esla, Inc		Apply Gross Vehicle Weight Correction		
SB-20-19-001		Sticker, South Rorea			
September 11, 2020					
Classification		Section/Group	Mobile Service		
Campaign Bulletin		19 - Labels	Can Perform (where permitted)		
Model Year	Model	Country/Region	Version		
2020	Model 3	South Korea	All		
The model(s) and model year(s) listed are a general approximation of the affected VIN list. Refer to the VIN/Bulletin Tracker or Customer/Vehicle profile to determine applicability of this bulletin for a particular vehicle.

Certain Model 3 vehicles manufactured for South Korea have certification labels with incorrect Gross Vehicle Weight values.

Figure 2

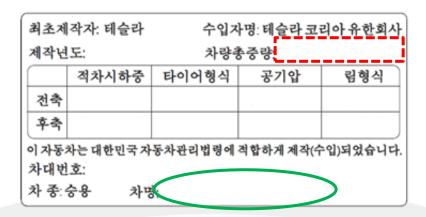
2. Compare the Vehicle Name at the bottom of the certification label (Figure 2) with the first column of the table to find the corresponding correction sticker.

- 3. Apply the correction sticker over the Gross Vehicle Weight value at the top of the label (Figure 2).
- 4. Use the silicone roller to apply pressure and set the correction sticker, and then close the driver door.

Vehicle Name	Correction Sticker
MODEL 3 STANDARD RANGE PLUS RWD	1950 kg
MODEL 3 LONG RANGE	2185 kg
MODEL 3 PERFORMANCE	2195 kg
